PREPARED FOR THE URBAN DESIGN COMMISSION

Project Address: 425 West Washington Avenue
Application Type: Applicant Request for Advisory Opinion
Prepared By: Kevin Firchow, AICP, Planning Division

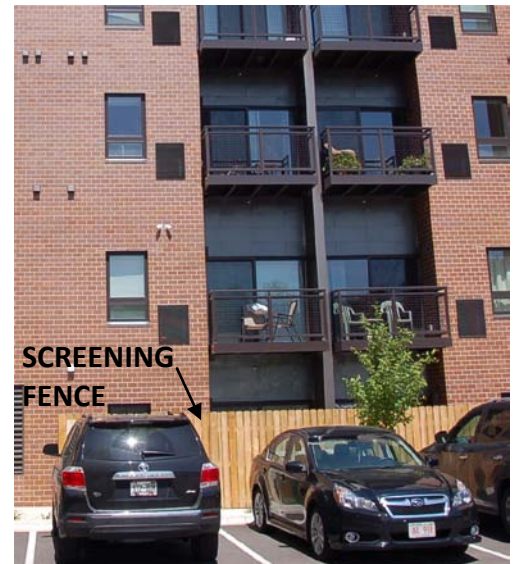
Below are images of how these improvements were installed. The installation of the wooden privacy fence is believed to be more of a suburban residential character and less appropriate in character for this site. The Planning Division had similar concerns on the appearance of the wooden roof-top fence, which is visible from West Washington Avenue.

- **Revised Rooftop Fence.** As approved, this fence was intended to consist of dark-bronze metal fencing, which remains preferable to staff. As opposed to installing metal fencing consistent with the original approval, the applicant hopes to modify the installed feature by lowering the height of the wooden lattice work, painting it dark bronze and capping it with a 1.5 inch pipe rail, painted dark bronze. The Planning Division has some concerns with this approach, noting that it appears while shortened, some of the wooden lattice work will remain visible from the street and the overall height increased. Staff had the understanding that alterations were to either replace this feature or not make it visible. Staff also has concerns on how integrated these two materials will ultimately appear and how other details, such as how the pipe will “turn corners” will occur.

- **Ground Level Screening Fence.** While not clearly labeled, the applicant has confirmed that the lower four feet of the fence will remain wood and a two-foot section of metal lattice, matching the balcony lattice will be added. They will be painted dark bronze to match similar balcony details on the building. Staff continues to have some questions on how those elements fastened together and how integrated these two materials will ultimately appear.
